Post Operating Exam Comment #1

Scenario 2 Critical task 3 states:

Post Operating Exam Comment #2

Post Operating Exam Comment #3

PLOT-23

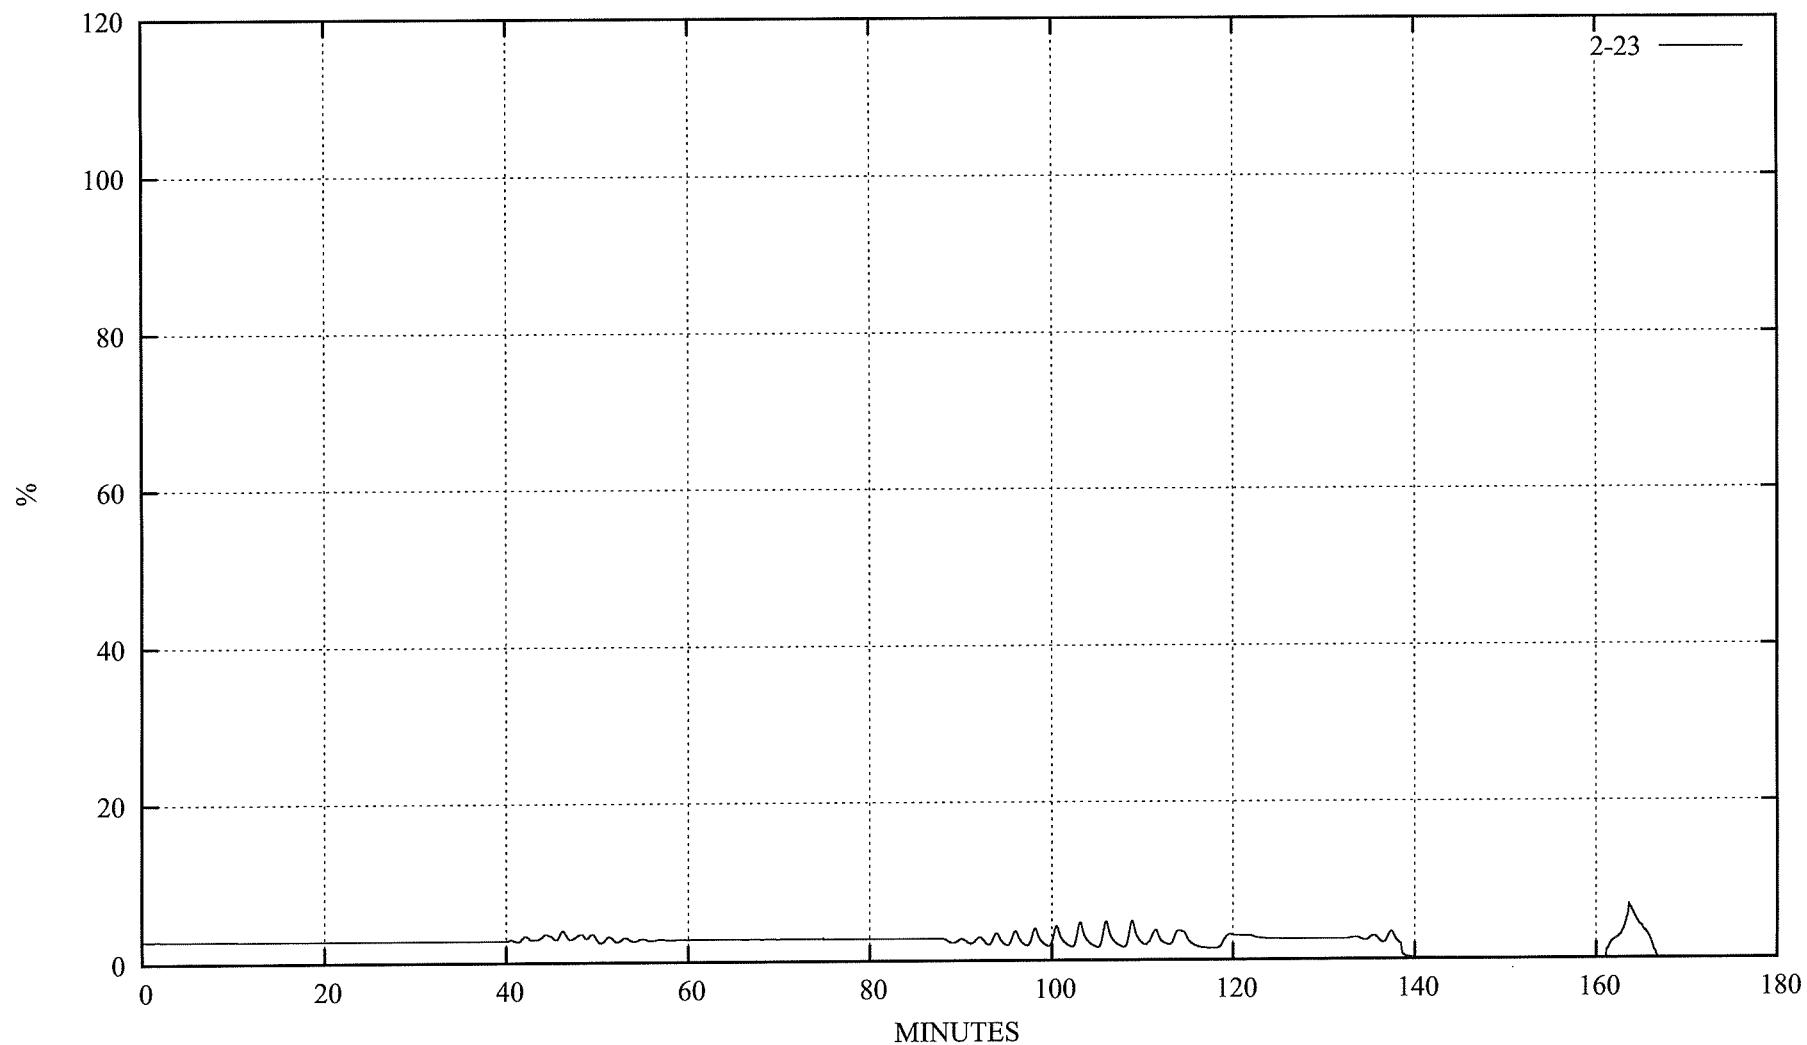
Crew B did terminate and prevent RPV injection from ECCS and Feedwater until reactor pressure was below the MSCP however; they did momentarily exceed the APRM downscale setpoint of 5% power once RPV injection was reestablished.

IF Reactor power is above 5% or unknown **And** Reactor water level is above (-) 50 inches **Then** go to step C5-5. (Note that the APRMs could be above 5% and no action is required as long as Reactor water level is below (-) 50 inches, see EOIPM section 0-V-K). The Crew recognized that that Reactor power and Reactor water level were rising and injection was stopped prior to exceeding (-) 50 inches. Reactor water level lowered rapidly to approximately (-) 87 inches and the operator resumed injection with condensate. Reactor power momentarily exceeded 5% and Reactor water level reached (-) 50 inches. The conditions for step C5-5 were not met because with Reactor pressure less than 50 psig above suppression chamber pressure the MSRVS would be closed. The crew immediately secured injection IAW C5-9 and Reactor water level immediately lowered to below (-) 50 inches allowing injection to the Reactor to be resumed IAW C5-10.

See attached Plots of Reactor Power, Pressure, and Water level.

The facility recommends removing the statement below from the Critical task.

During an ATWS, when conditions with Emergency Depressurization required, Terminate and Prevent RPV injection from ECCS and Feedwater until reactor pressure is below the MSCP, then restore and maintain Reactor water level above (-) 180 inches.

This Critical task is not met if the crew fails to recognize and take action to secure injection to the Reactor if the conditions of C5-5 or C5-15 are met.
